6. Assessment of Issues in the Estuary

6.2 Summary of issues raised downstream of Seaham Weir

6.2.1 Estuary modelling

Figure 6.1 Estuarine reaches (Source: Manly Hydraulics Laboratory, 2003 and BMT WBM, 2010)

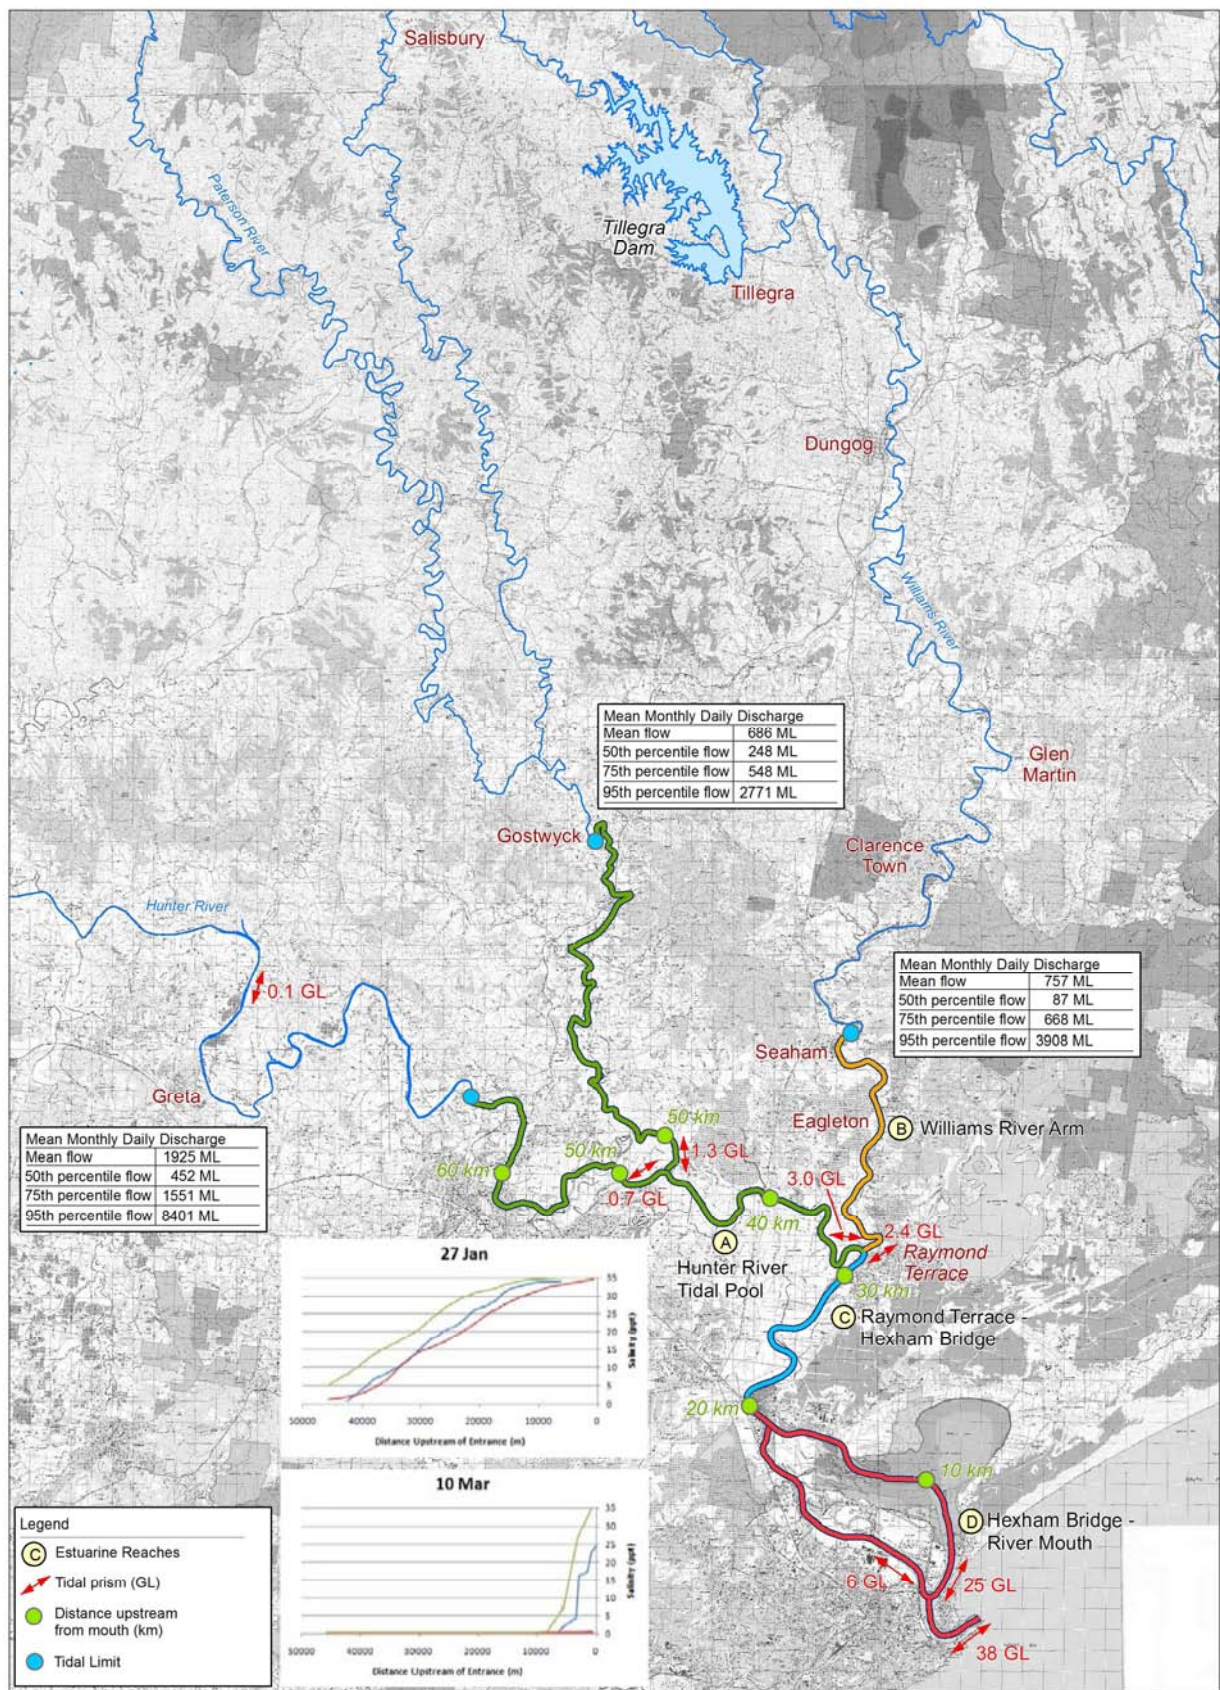
The NOW submission suggests the Hunter Estuary can be broadly divided into four segments as follows: (refer Figure 6.1):

Across the submissions there appears to have been confusion about the relative impacts of the Williams River flows at various locations along the Hunter River Estuary. It is important to specify the location of the area of interest related to specific issues. This is required as the balance between the oceanic tidal processes, that energise the estuary from the ocean and the freshwater inflows, which energise the estuary from the catchment can vary substantially along the system.

The segments or estuarine reaches are shown in Figure 6.1 along with the variation in tidal prism and salinity concentrations, which essentially reduce with distance upstream from the mouth and a summary of the freshwater inputs to the estuary from the Hunter River at Greta, the Paterson River at Gostwyck and the Williams River at Seaham.

In the following sections the relative contribution of the Williams River inflow to total freshwater flow in the Hunter River is estimated for each reach. Note that this relative contribution diminishes with increasing distance downstream of Seaham Weir.

Figure 6.2 Mean monthly discharge (ML/d) for the Hunter, Paterson and Williams Rivers.

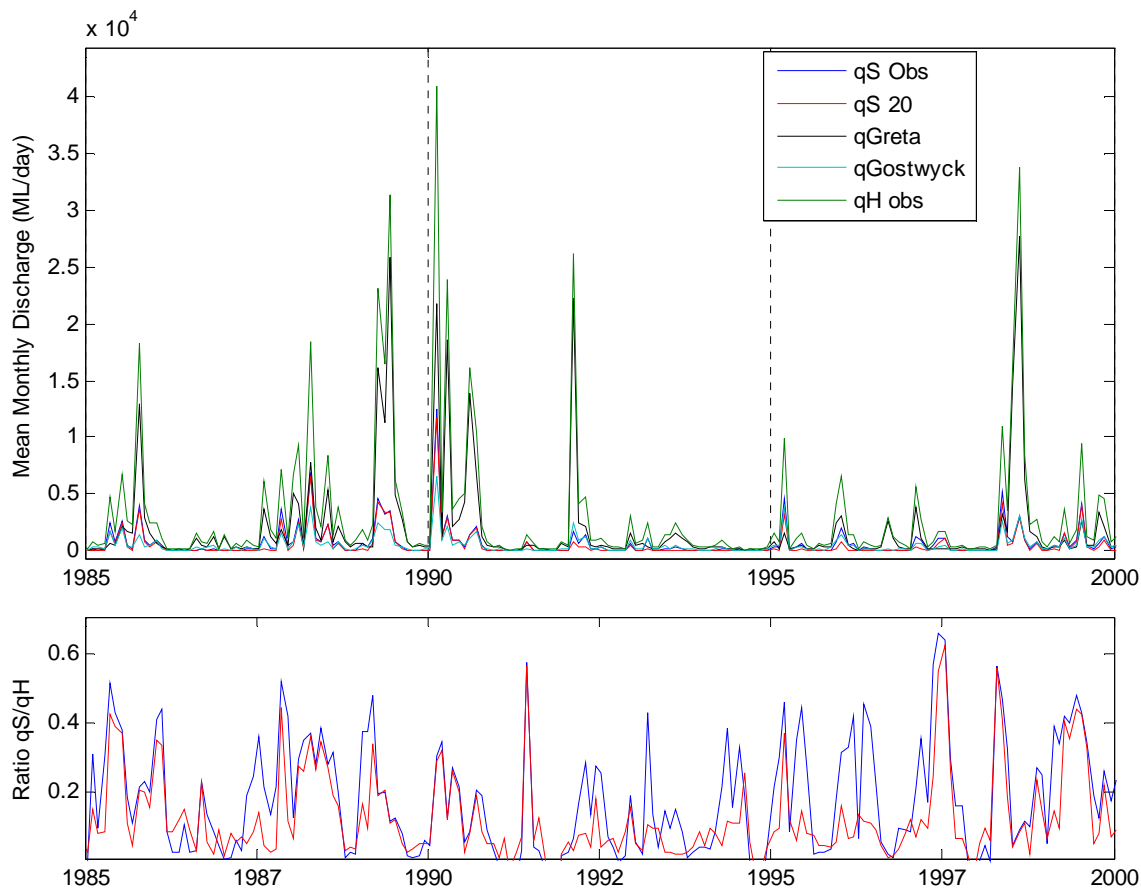
A number of submissions were concerned that Tillegra Dam would increase salinity levels and reduce the availability of water to irrigate from the tidal pool of the Lower Hunter and Paterson Rivers. Respondent's thought further investigations into the relative contributions of the Hunter River and the Williams River to the Hunter River Tidal Pool is required.

As the primary interest here is to gauge the impact on the tidal pool and particularly flushing, the daily flow data were aggregated to monthly mean daily flows at each site as shown in Figure 6.2. Denoting the data sets as:

The ratio of flow at Seaham to the total flow in the Hunter River Tidal Pool (qS/qH) for the current ($qS\ Obs$) and post Tillegra ($qS\ 20$) scenarios provides a measure of the likely reduction in flow to the estuary post Tillegra Dam as shown in Figures 6.2 and 6.3.

Results show that the relative contributions of the Williams River flows to freshwater flows to the Hunter River Tidal Pool are highly variable for the period 1985 to 2000 ranging between zero and 60%, however, on average the William River flows account for around 23% of the flow to the Hunter River Tidal Pool. It should be noted that total flow estimates into the Hunter River Tidal Pool are conservative as the runoff from a large area of catchment downstream of gauging stations have not been taken into consideration.

The likely reduction in freshwater flows to the estuary as a result of the project is shown in Figure 6.2. The contribution of the Williams River to total Hunter freshwater flows would be reduced on average by around 5% following operation of Tilleggra Dam. There would be little change in the inter-annual variability in flows.
